FILE P. I. No. 0006725, Douglas County
CSSTP-0006-00(725)
Douglasville Sidewalks

SUBJECT APPROVED REVISED PROJECT CONCEPT REPORT

REVISED PROJECT CONCEPT REPORT

PHASE I

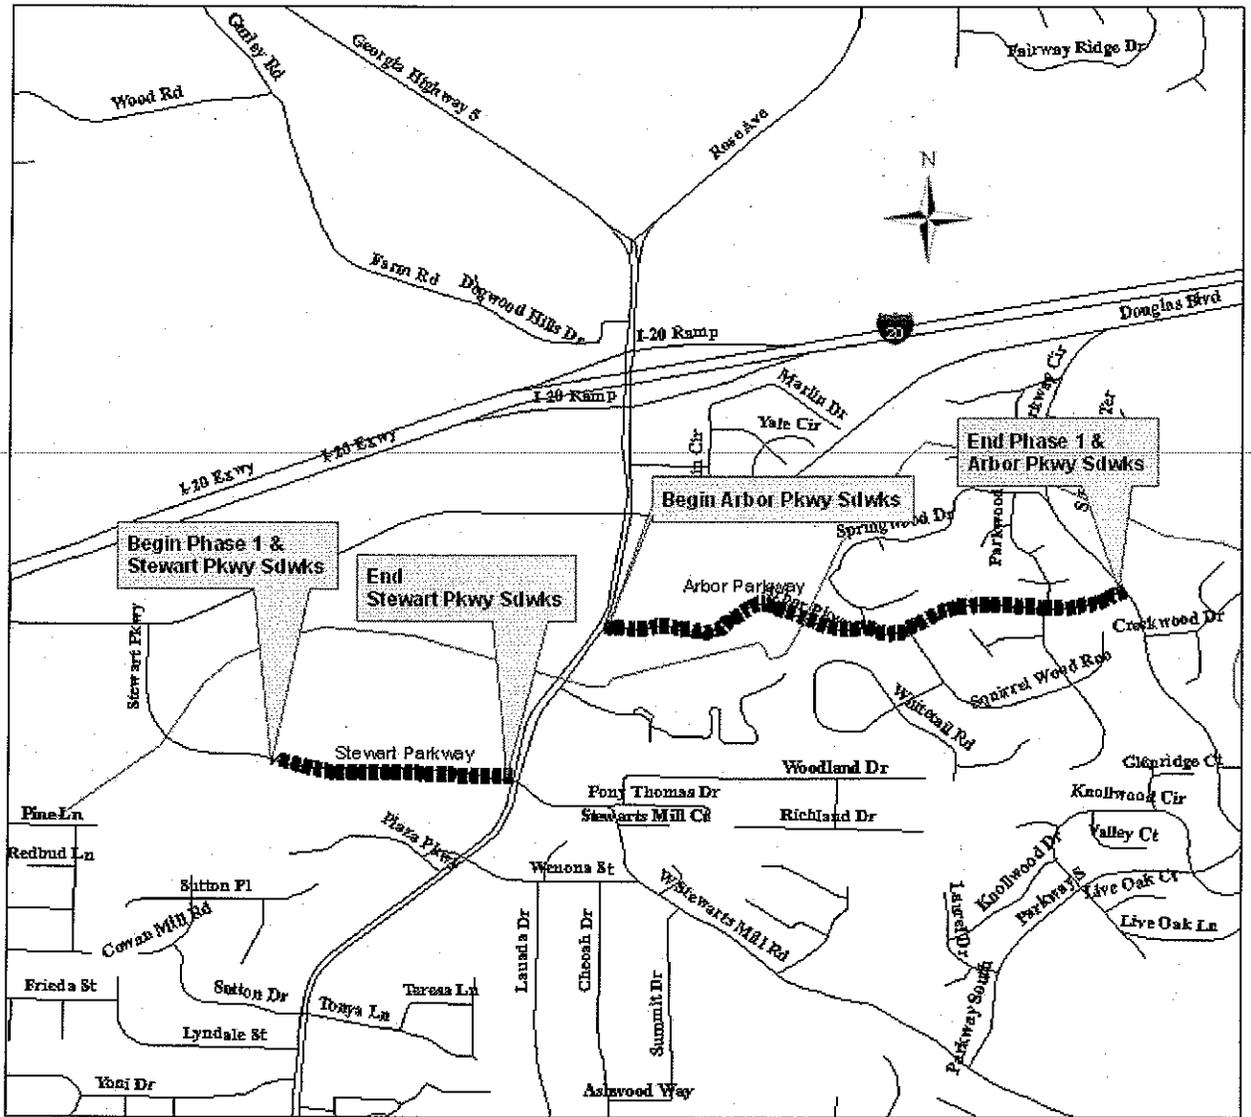
Proposed Features to be revised: In the interest of time and expediency during right of way acquisition, the approved concept has been amended as follows:

1. No changes are planned on the proposed typical section.
2. With regard to changes to the project termini, the project has been subdivided into two separate phases as follows:

Stewart Parkway from Highway 5 to U.S. Post Office, on north side of the road;
and
Arbor Parkway from Highway 5 to Parkway Circle, on south side of the road.

The project has been subdivided into two separate phases: Phase 1 to include the improvements to Stewart Parkway and Arbor Parkway; and Phase 2 to include the improvements to Malone Road.

PHASE II

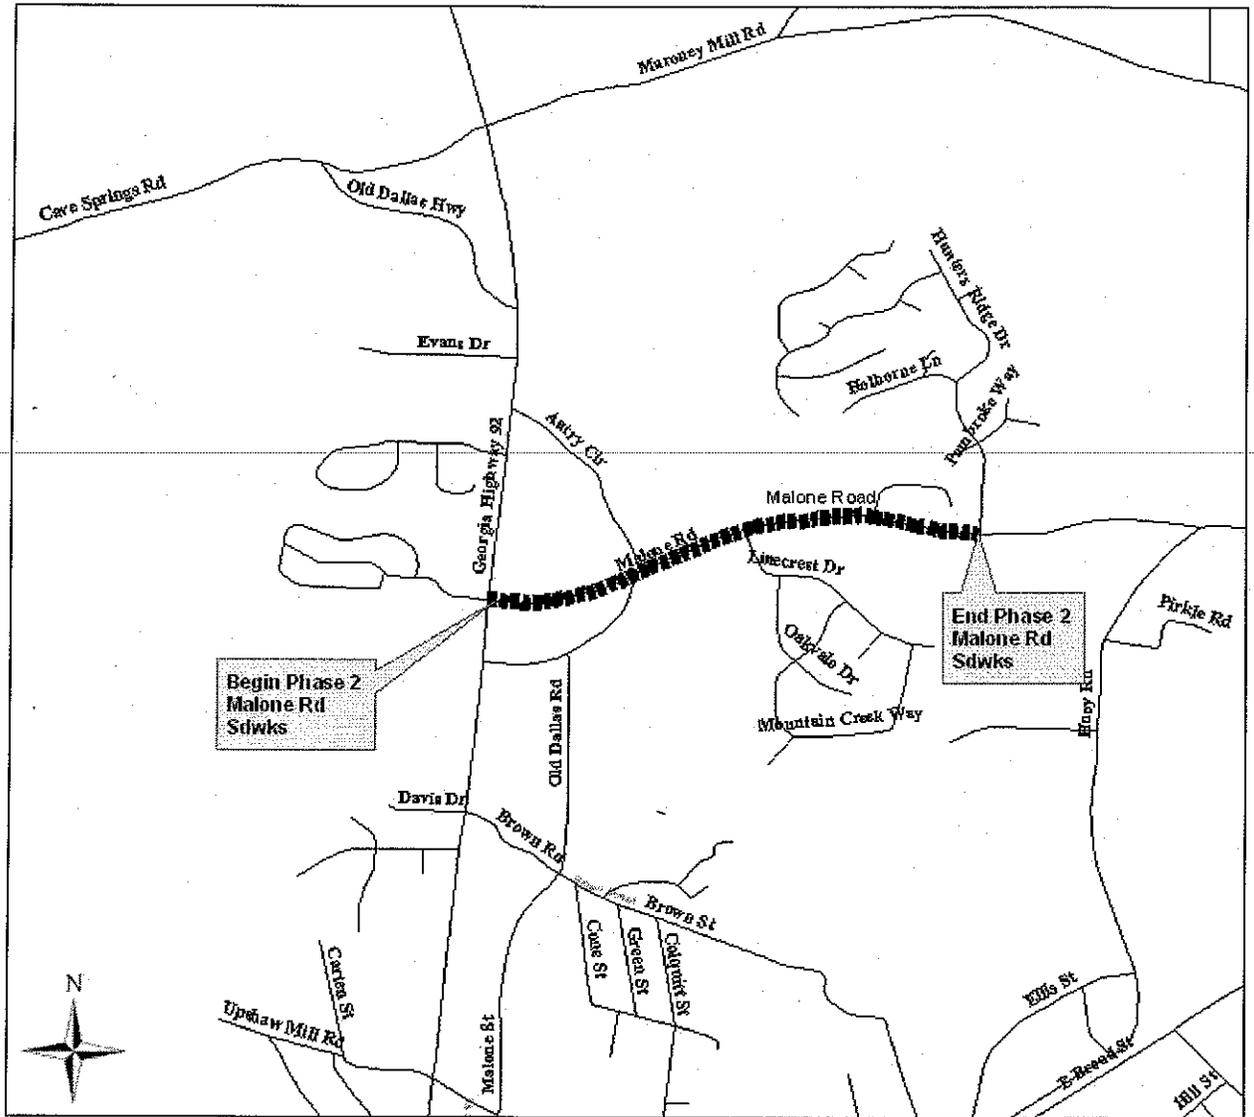
Malone Road from Dallas Highway (SR 92) to Hunters Ridge, on south side of the road.
